**AGENDA
TECHNICAL REVIEW COMMITTEE
REGULAR MEETING
DECEMBER 22, 2022
10:00 AM
CITY HALL COMMISSION CHAMBERS
204 ASH STREET
FERNANDINA BEACH, FL 32034**

5.1 TRC 2022-0028 - TIM POYNTER, 116 N. 2nd Street
Site plan review for the construction of a multi-use pavilion and pickleball courts.

ENGINEERING PLANS
FOR
STANDARD MARINE
COVER SHEET
NASSAU COUNTY, FLORIDA

YIELD ANALYSIS PLAN
FOR
STANDARD MARINE
SITE PLAN

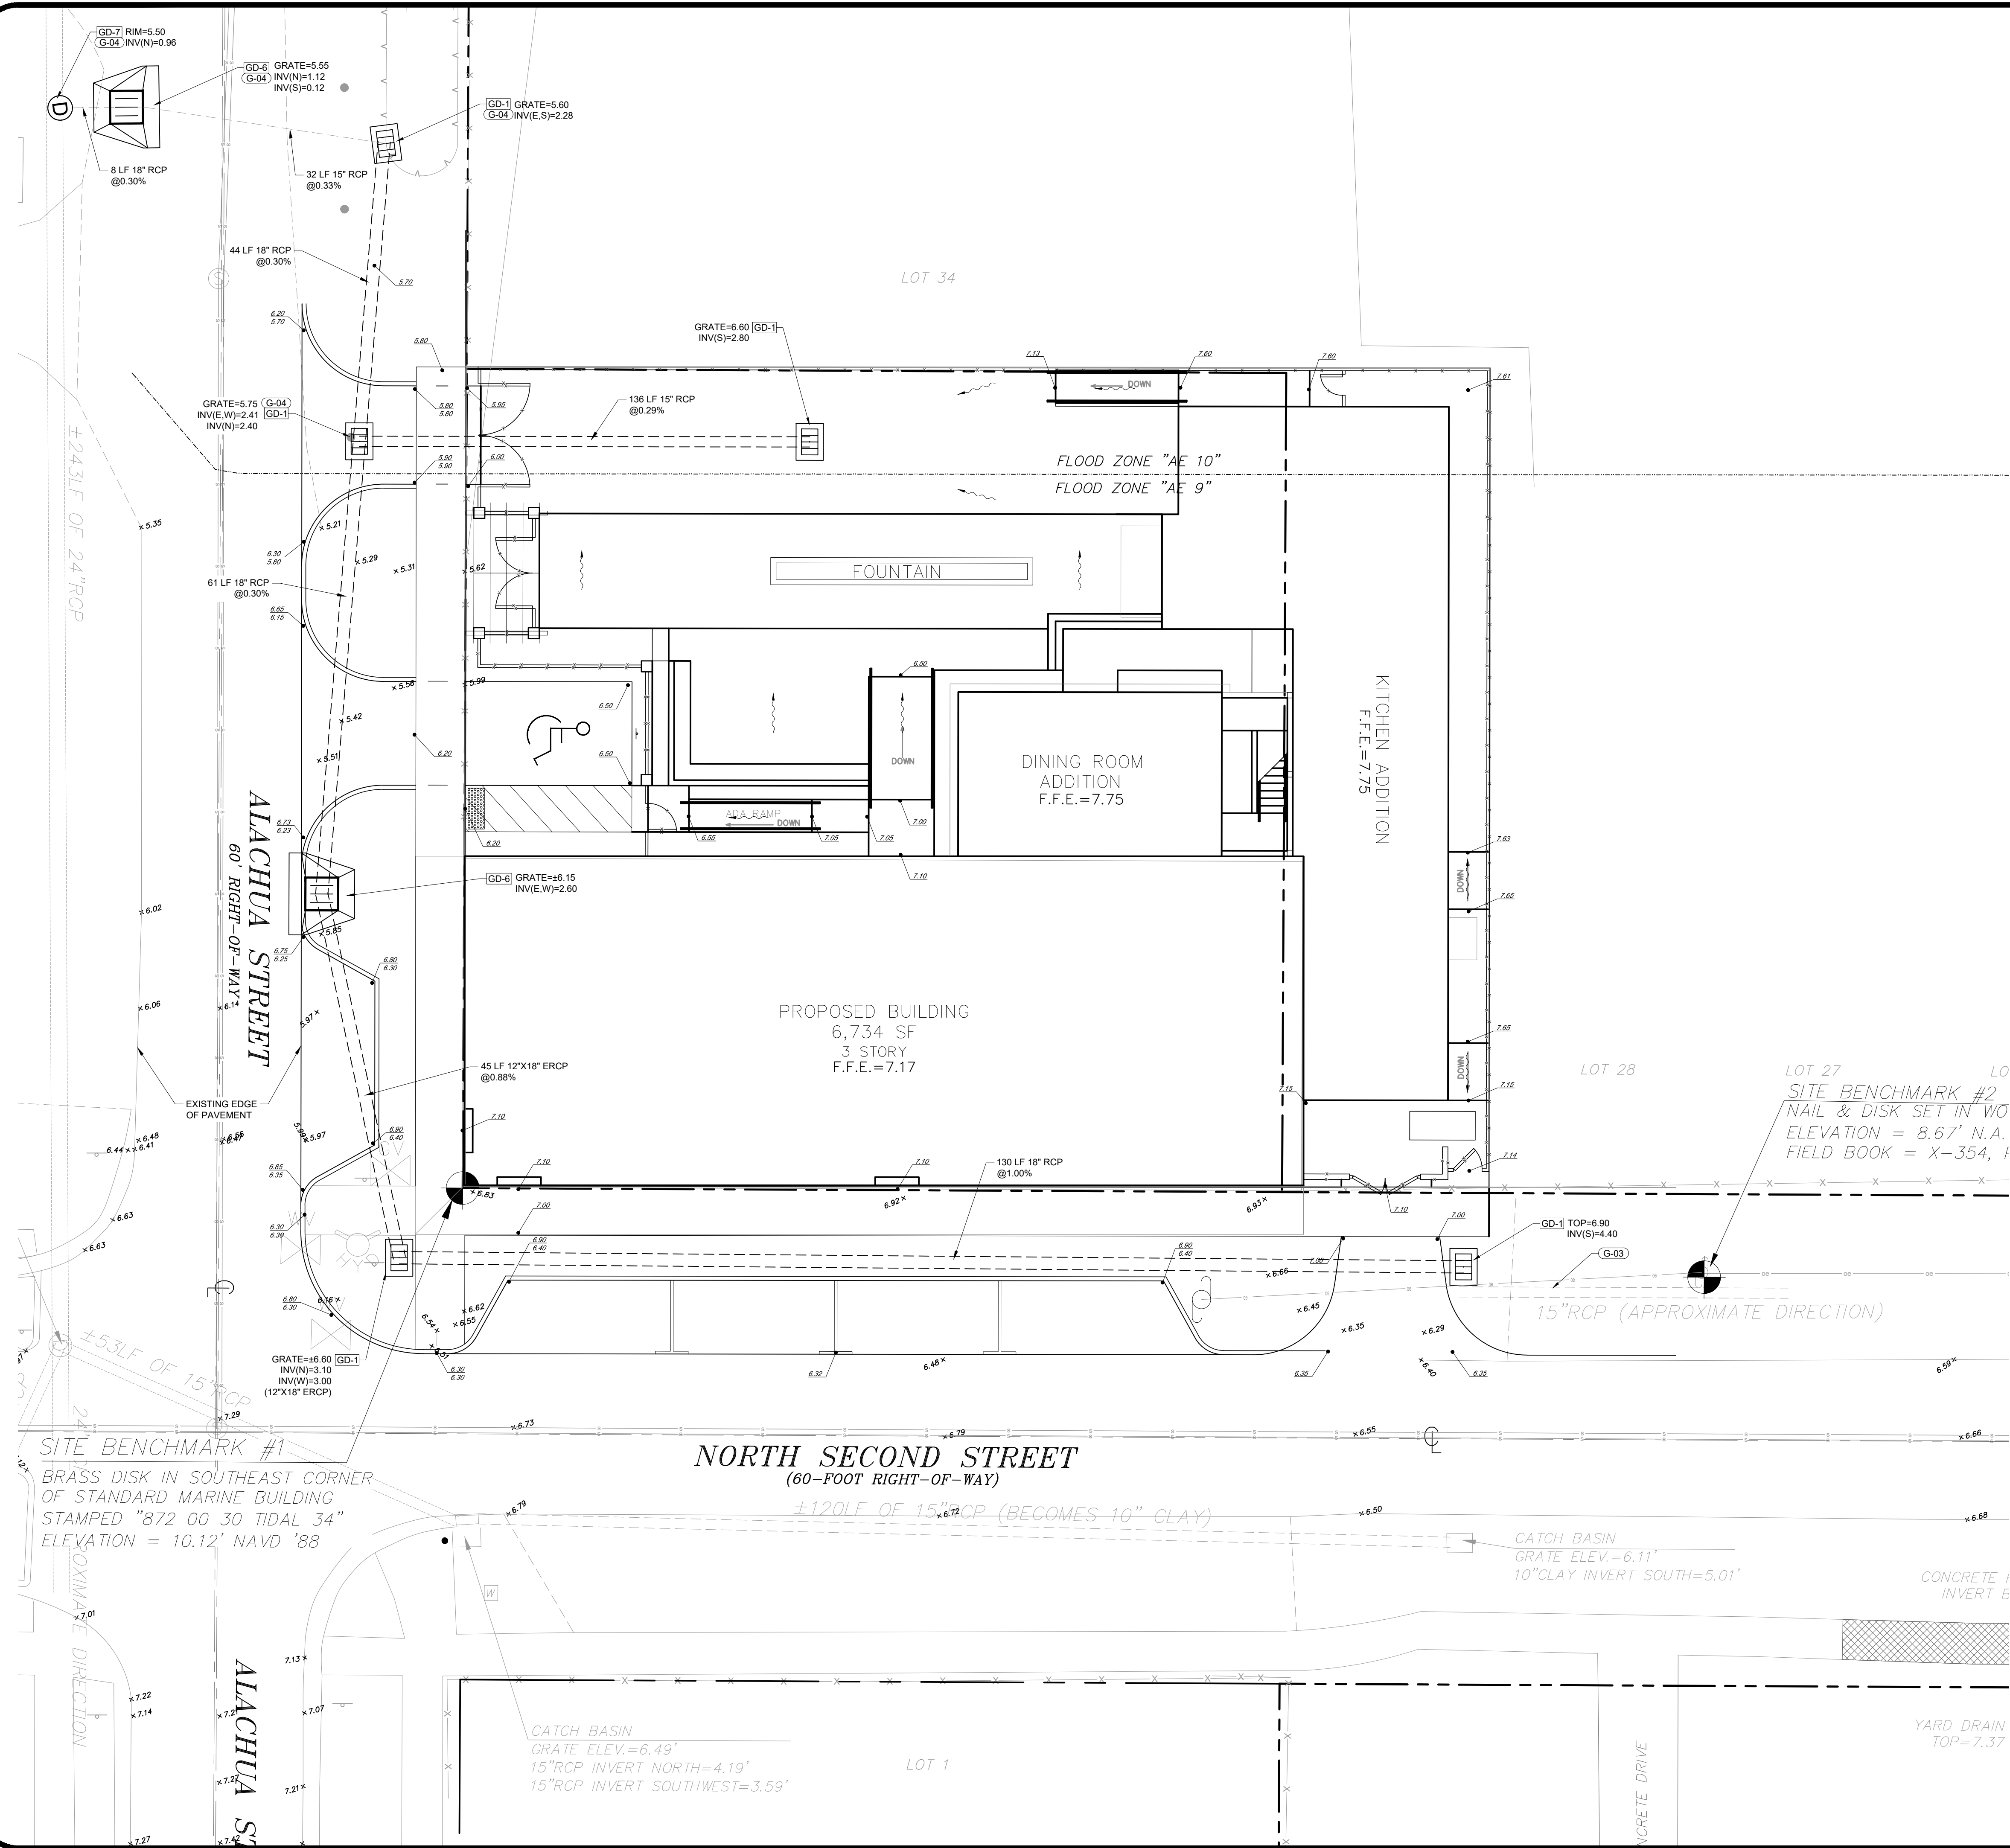
3. Please indicate what surface the West side by the structure is. Area is identified as "SD-?" on sheet 6.

GDG: Please refer to the detail Sheet 9 of the civil plans to find the specifics on SD-18 ADA Detectible warning.

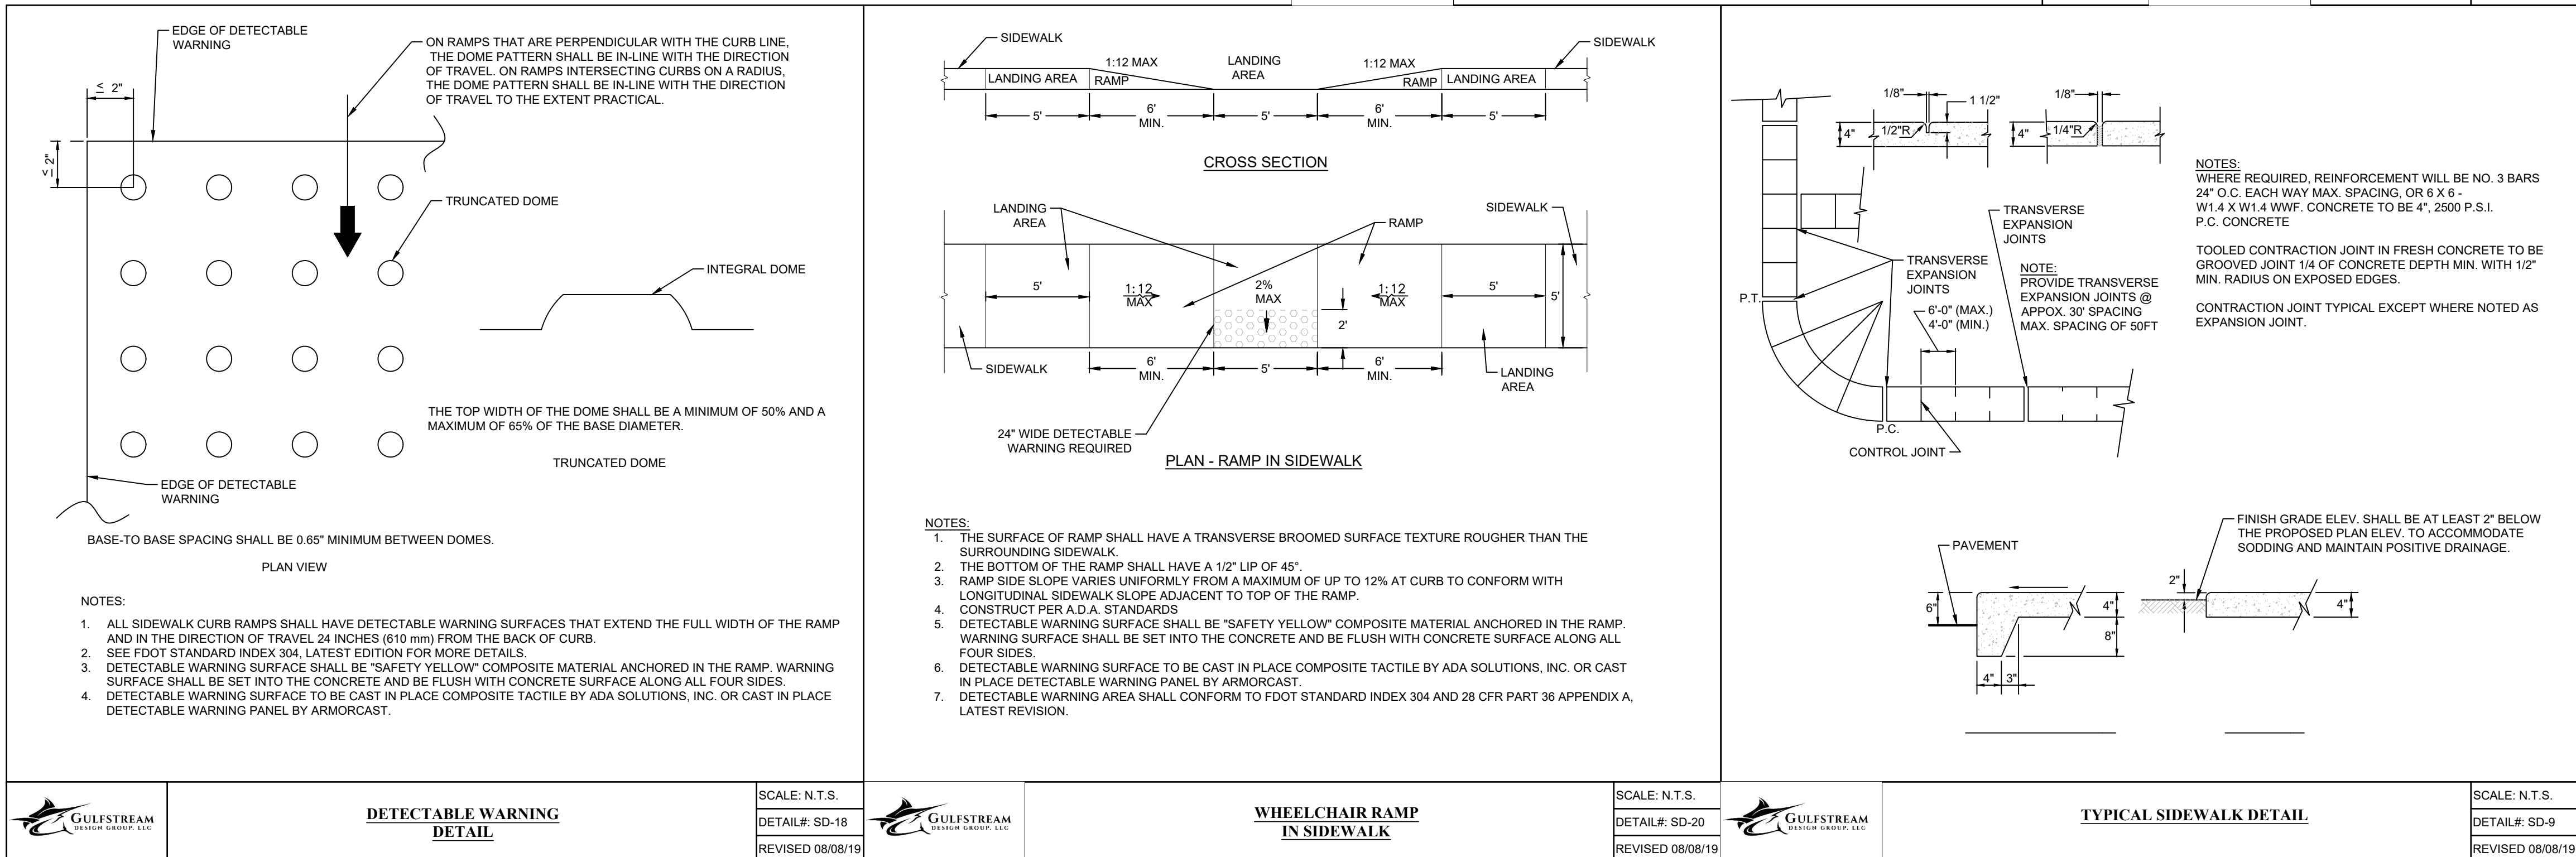
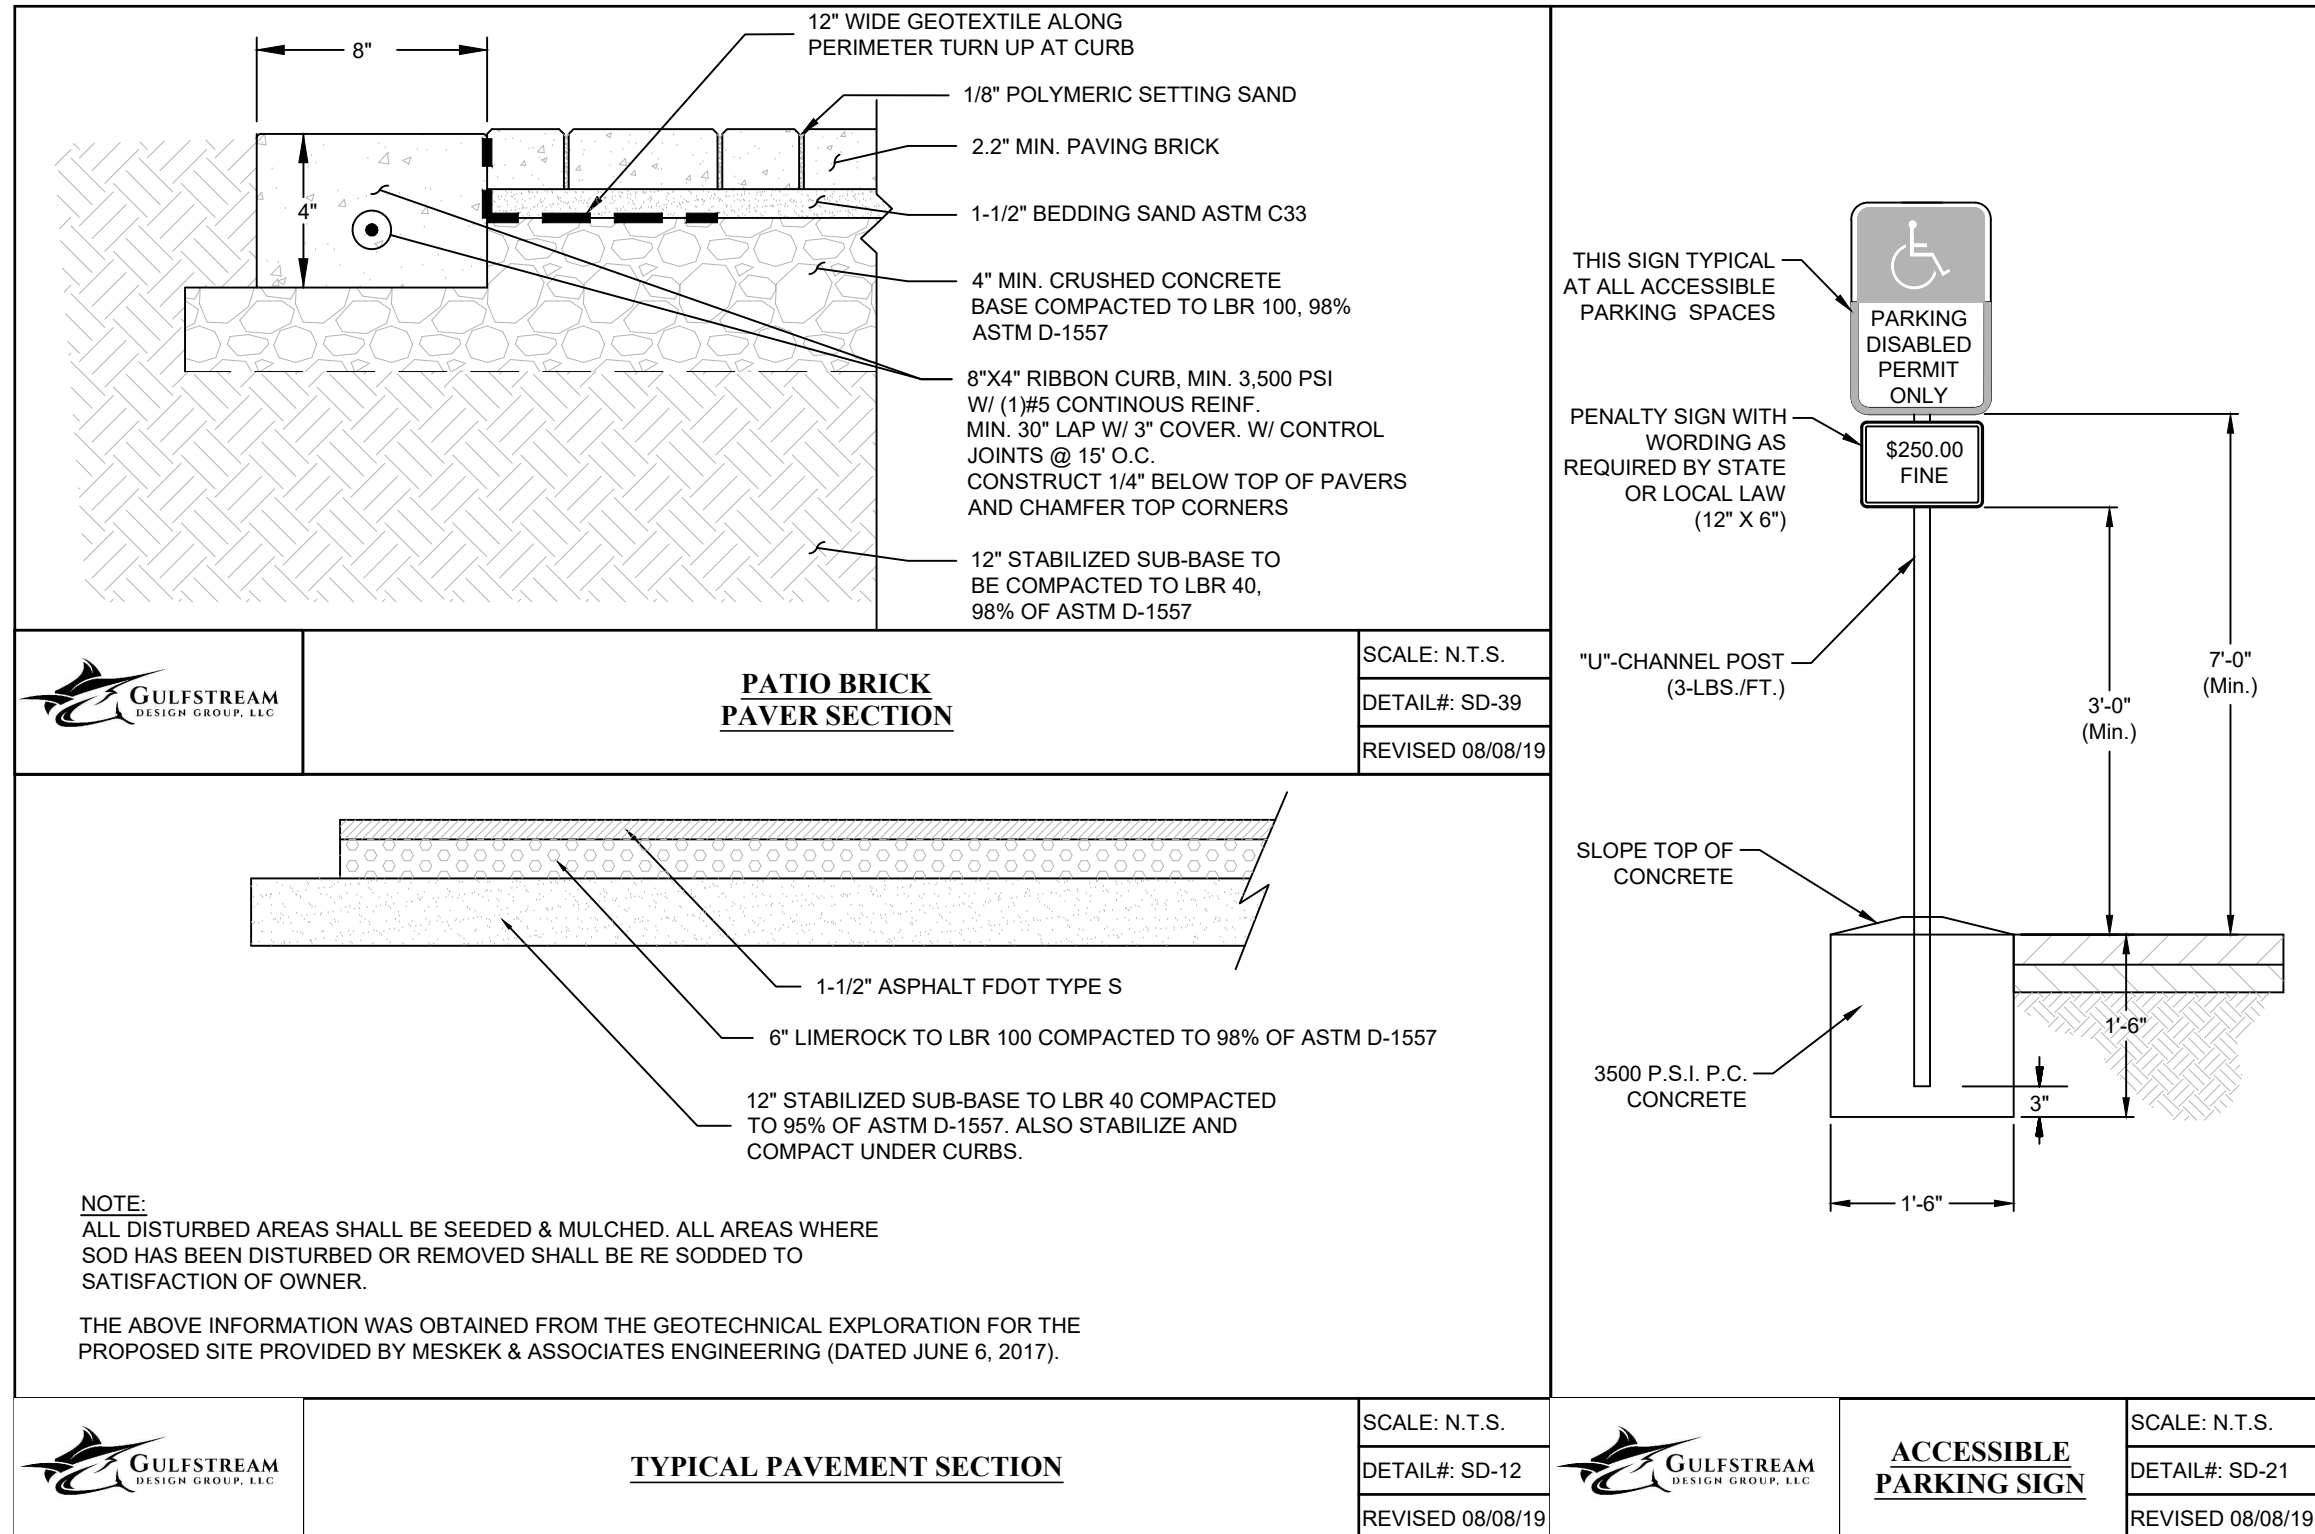
2. Please provide location and details of the fire suppression system's underground fire main, RPZ backflow preventor, and the Fire Department Connection (FDC). As well as the location of the riser room where the underground fire main terminates. No further comments. 10/24/22 JSH

GDG: Please refer to Sheet 8 of the civil plans. The firemain and appropriate fittings have been shown and called out.
